**Florida Department of Transportation  
RE-EVALUATION FORM**

**1. GENERAL INFORMATION** (originally approved Environmental Document)

N/A	424501-1	#12556
Federal Aid	FM	ETDM
- d. Project Name, Location and Limits (from original document):

**3. EVALUATION OF MAJOR DESIGN CHANGES AND REVISED DESIGN CRITERIA**  
 (e.g., Typical Section Changes, Alignment Shifts, Right of Way Changes, Bridge to Box Culvert, Drainage Requirements, Revised Design Standards)

**I-275 Mainline Type 2 CE Approved Build Alternative Typical Section from south of 9th Street North to north of 4th Street North (Segment C-MP3)**

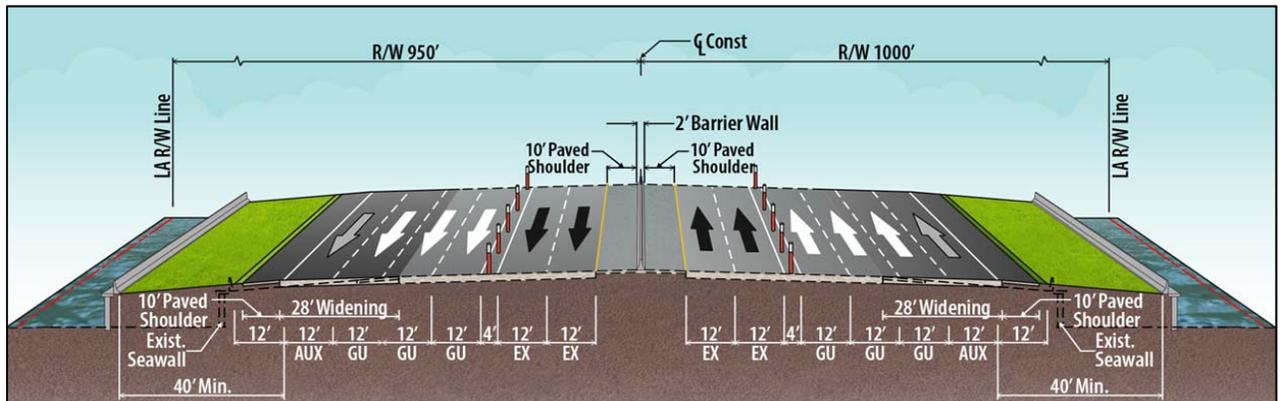
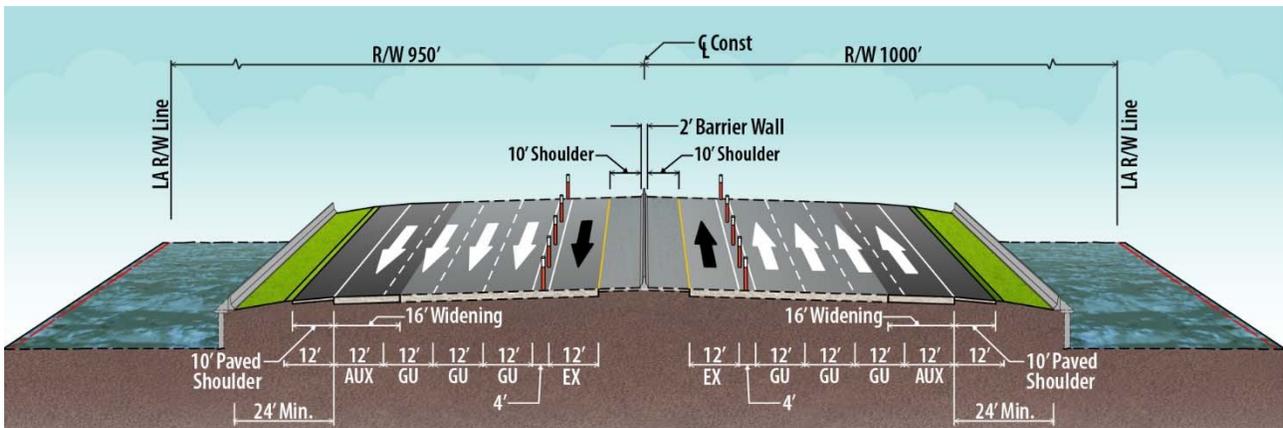
A Typical Section Design Change is proposed in order to repurpose the approved Type 2 CE express lane configurations within the portion of Segment C from south of 9th Street North to 1.0 Mile south of the Howard Frankland Bridge. This portion of Segment C is subdivided into two sub sections:

- from south of 9th Street North to north of 4th Street North (Segment C-SP3)
- from north of 4th Street North to 1.0 Mile south of the Howard Frankland Bridge (Segment C-SP4)

The repurposing of one (1) of the two (2) approved Type 2 CE express lanes is needed in order to accommodate the provision of three general use through lanes, one auxiliary lane, and one express lane in each direction throughout these limits with the Starter Project improvements.

The Type 2 CE Preferred Build Alternative Typical noted in the 424501-1 PD&E Study limits portion from south of 9th Street North to 1.0 Mile south of the Howard Frankland Bridge are shown below:

**I-275 Mainline Planned Typical Section Design Change Build Alternative from south of 9th Street North to north of 4th Street North**
